PRODUCT/PROCESS CHANGE NOTICE (PCN)

PCN #: **TB1303-02** DATE: **April 1, 2013**
 Product Affected: Selective Non-Dry Pack Products
 shipped in Tape & Reel
 (Refer to Attachment 2)

PCN Type: Packing Method

Figure1: Illustration on Existing Packing and New Packing for Non-Dry Pack Products

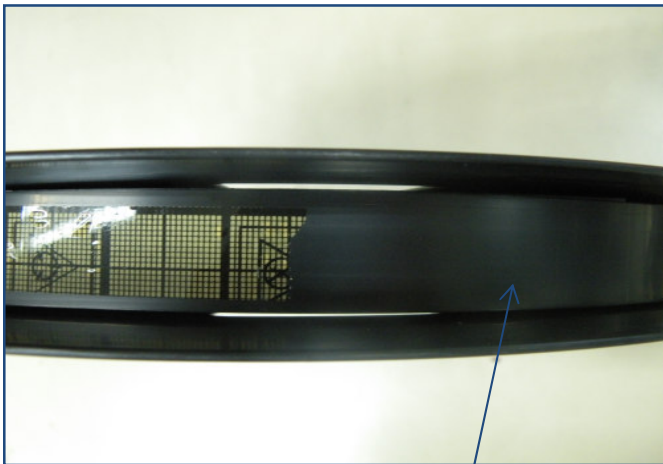
This notification is to advise our customers that IDT will be changing the packing method for selective Non-Dry Pack products (Moisture Sensitive Level 1) shipped in Tape & Reel. The new packing will be without the black protective band which is inserted in the outer carrier tape before the reel is packed into an ESD bag. All other packing materials remain unchanged.

A black protective band is inserted at the outer carrier tape before the reel is packed into an ESD bag.

New Packing -
Without Protective Band
